H2OAKS DESALINATION FACILITY WELL SITE DEVELOPMENT PROJECT

Job No.: 18-8607

ADDENDUM 4

May 15, 2020

SHEET: I-04

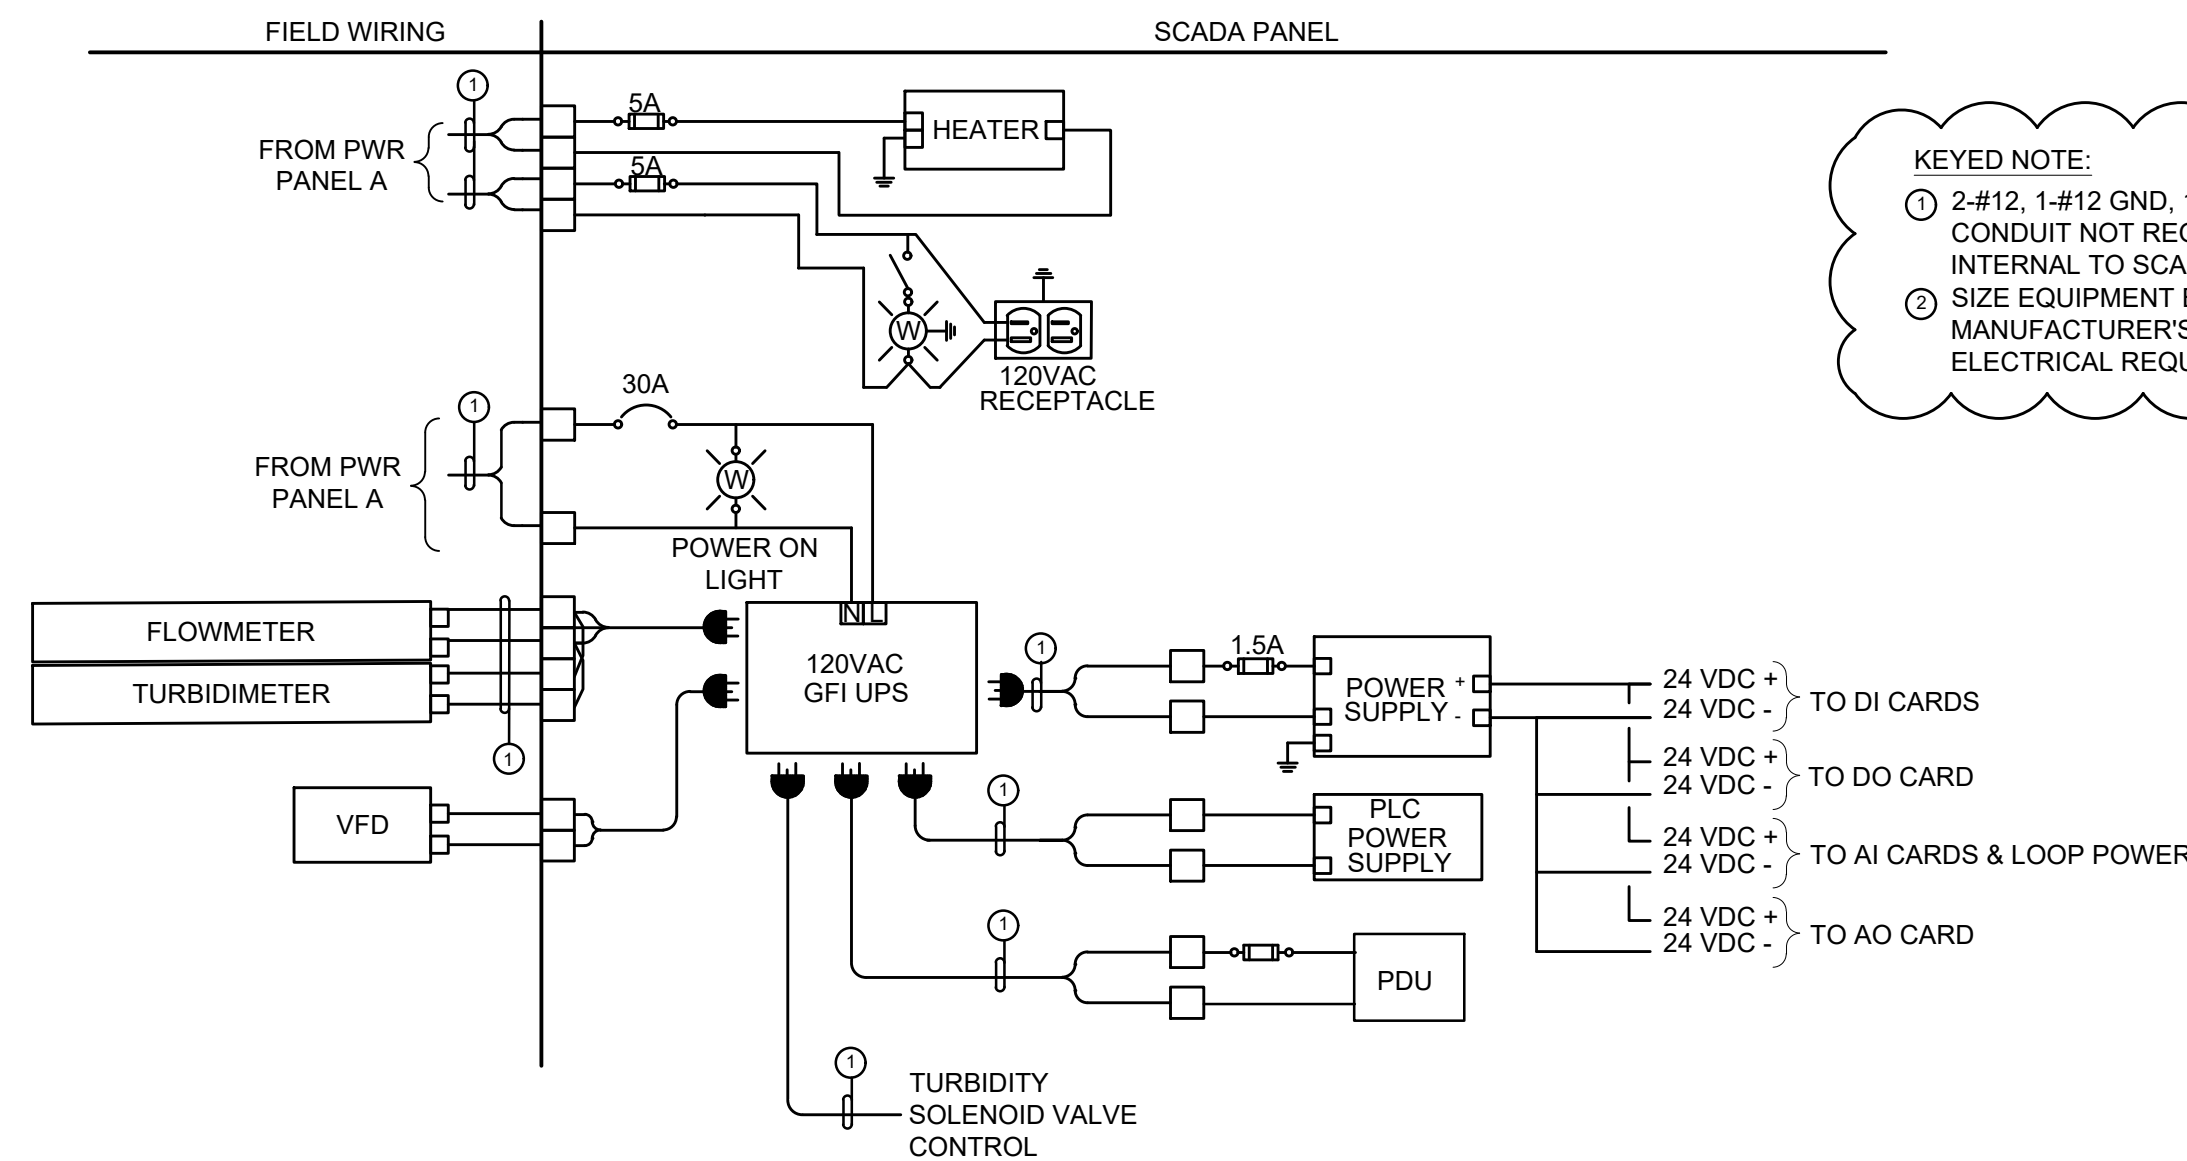
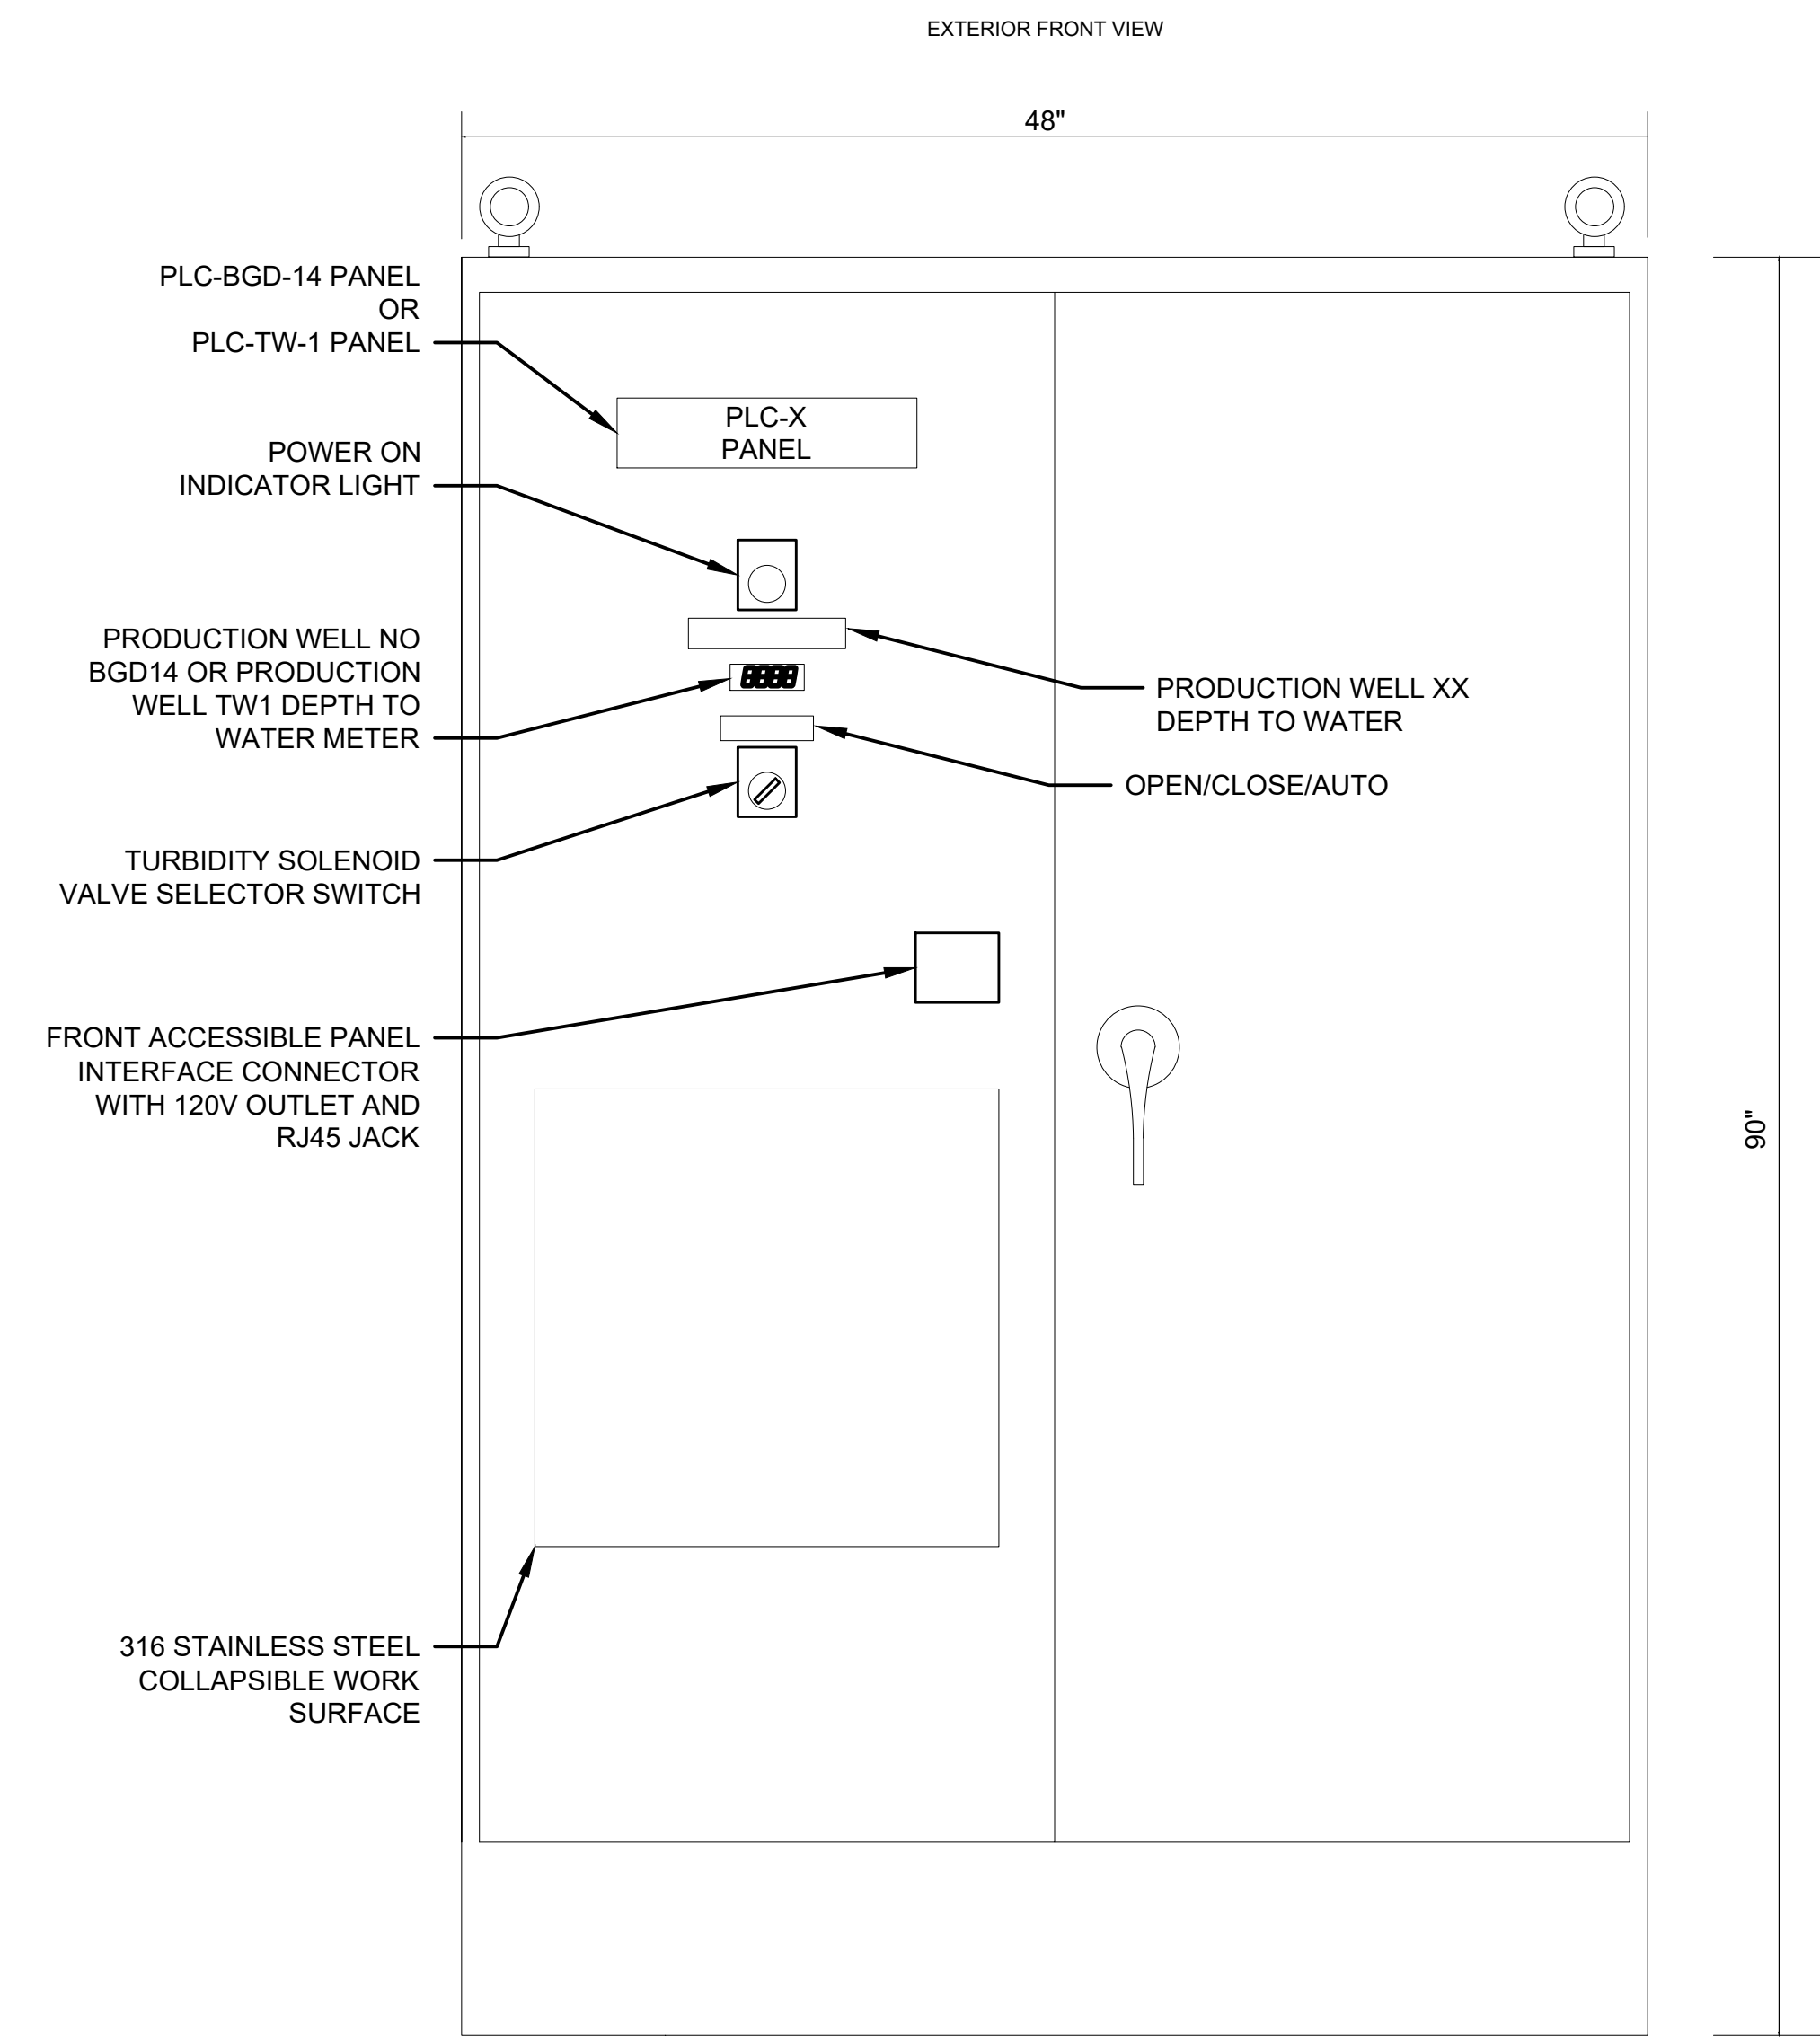
8. There are a couple of instances where wiring internal to equipment such as MCC, SCADA panel are shown to be in conduit. E-10 2-1/C#10, 1-1/C #10 GND in ¾" conduit from Branch Breaker Section of the MCC to Power Panel A & I-04 Keyed Note #1, 2#12, 1-#12, in 1" Conduit in from UPS to various AC power supplies within the SCADA Panel. Please clarify the intensions of these requirements.

Response: Refer to Changes to the Plans Items 4, 5, and 6 (sheets E-12, E-13, and I-04).

KEYED NOTE:
 ① 2-#12, 1-#12 GND, 1" C. CONDUIT NOT REQUIRED IF INTERNAL TO SCADA PANEL.
 ② SIZE EQUIPMENT BASED ON MANUFACTURER'S RECOMMENDED ELECTRICAL REQUIREMENTS.
